# AVN-20211202 Problematic MEMS Oscillator

<b>Company</b>	Trenz Electronic GmbH
<b>AVN Number</b>	AVN-20211202
<b>Title</b>	Problematic MEMS Oscillator
<b>Subject</b>	Information and remedy concerning problematic MEMS Oscillator
<b>Issue Date</b>	2021-12-09

possibly affected	not affected
DSC6111MI2A-025.0000	SiT8008BI-73-18S-25.000000E

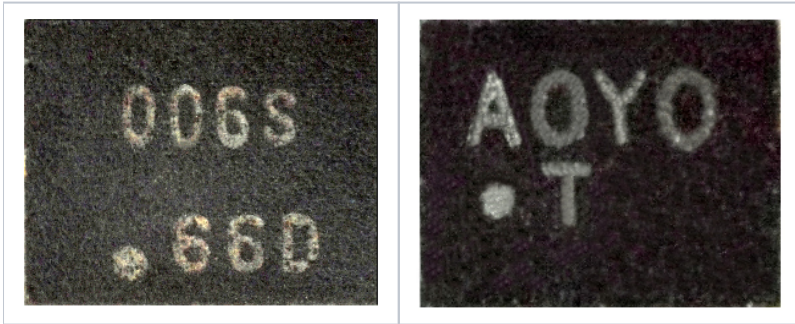
Due to component shortage from June to August 2021 some Trenz Electronic products were assembled with datasheet compatible DSC6111MI2A-025.0000 instead of SiT8008BI-73-18S-25.000000E. Although there is no evidence for any performance issues from the datasheets at least one batch of DSC6111MI2A-025.0000 has been identified to be root of issues in specific applications.

1. Ethernet communication with online available standard reference design is unreliably:
  - a. Standard ping test in separated environment results in package loss of up to 10% or
  - b. unexpected link up/down switches.
2. MGT communication fails, known to work designs showed no link.

1. Trenz Electronic opens a RMA and the affected MEMS is replaced at Trenz Electronic.
2. Trenz Electronic sends a SiT8008BI-73-18S-25.000000E for substitution to the customer.
